AGENDA
REGULAR MEETING OF THE
WINDSOR HEIGHTS CITY COUNCIL
Monday, June 3, 2024 - 6:00 PM
WINDSOR HEIGHTS COUNCIL CHAMBERS - 1133 66th ST
ZOOM: <https://us02web.zoom.us/j/7832856334>
Meeting ID: 783 285 6334

**STAFF REPORT
CITY COUNCIL**

SUBJECT: Public Hearing on the Proposed Plans, Specifications, Form of Contract, and
Estimate of Costs for the Windsor Heights CEC Solar Project

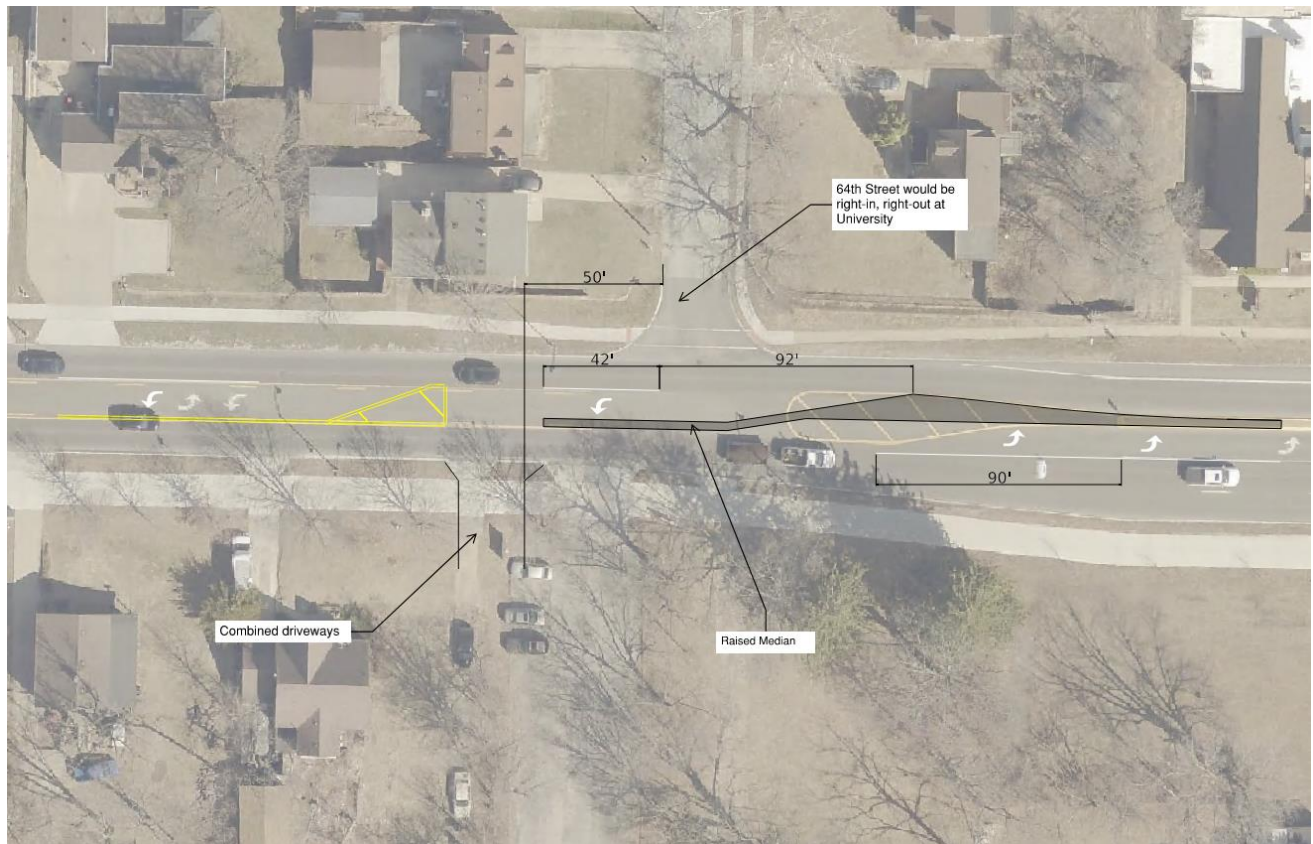
4. Indoor Long-Term Bike Parking and Car parking in garage don't work with the current design as people won't be able to get out of their cars. Please Address.

Traffic Other Comments

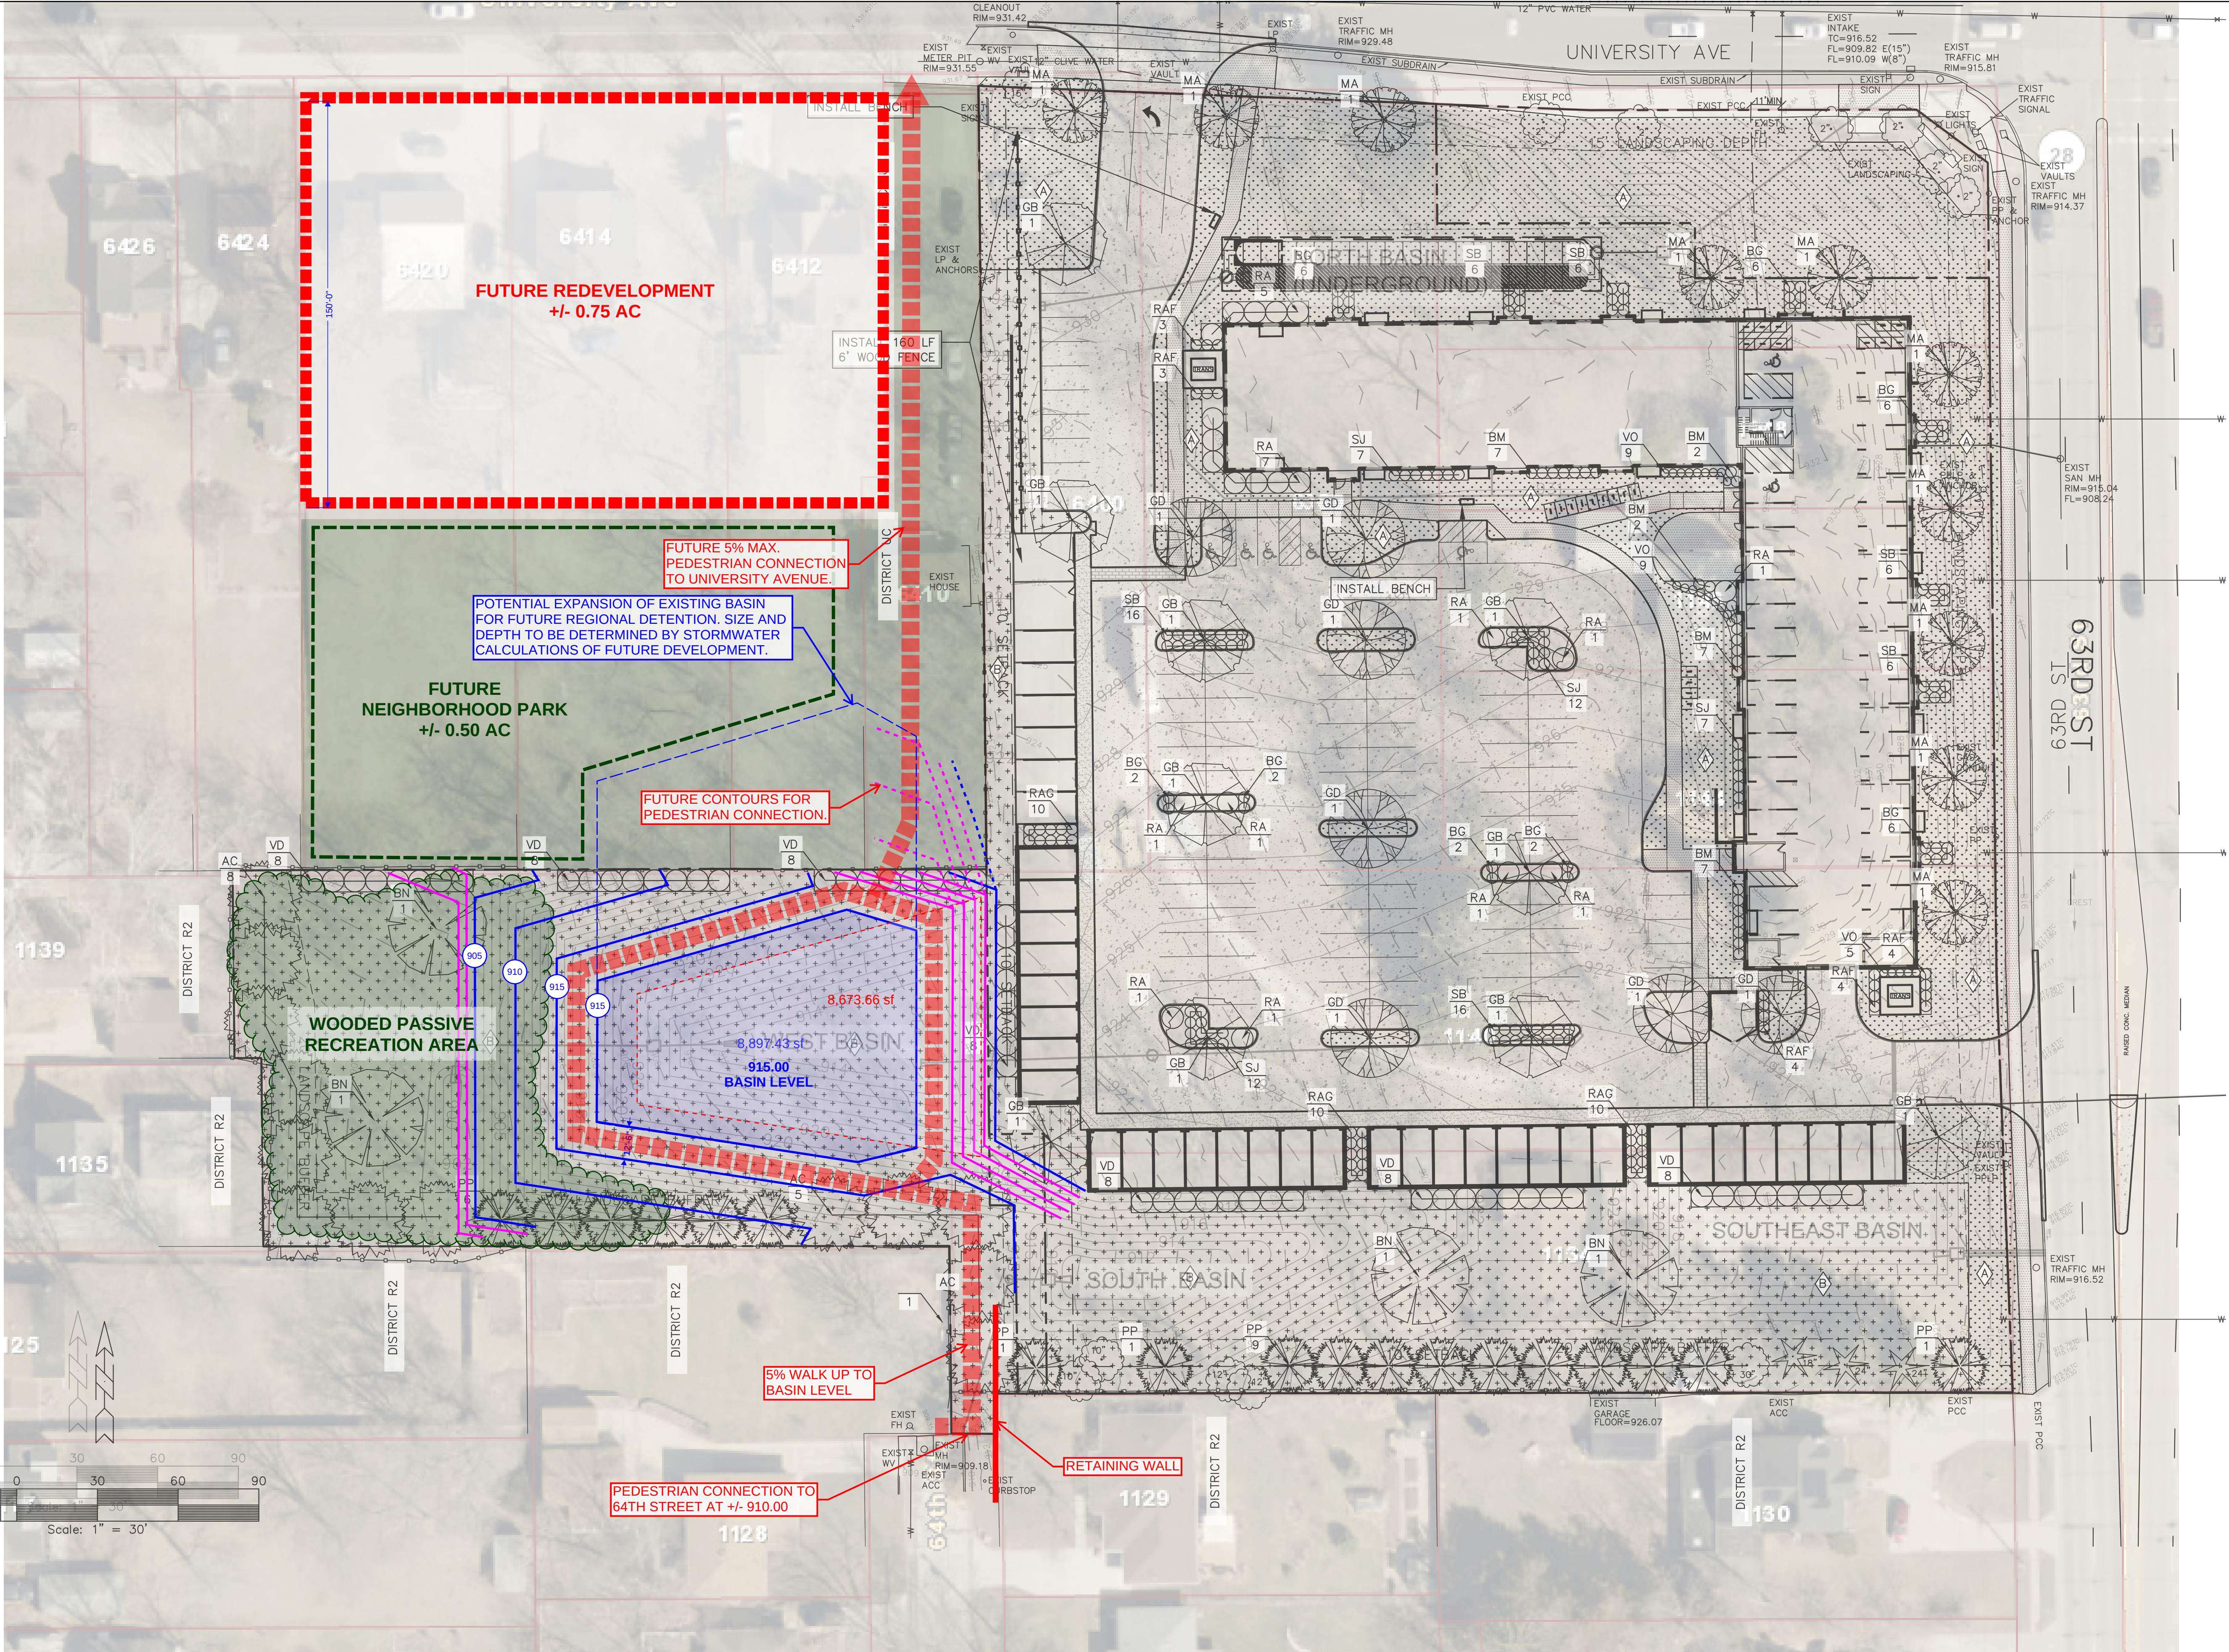
2. If Council chooses to allow the full access, City Administration recommends it be a temporary full access and a condition on the site plan approval. A temporary full-access shall be allowed on to University Ave as shown in the site plan. Said access shall be limited to a duration of five years from the date an occupancy certificate is issued for any structure built, after which time the city council must review the access to determine if the temporary full-access may continue or otherwise terminated and converted to a right-in-right-out only access. Temporary full access may also be terminated prior to five years as directed by the Council if they so determine said access has contributed to additional traffic conflicts or if roadway improvements are determined necessary. When temporary full-access is terminated, any action needed to discourage use as a full-access shall be a cost of the developer.
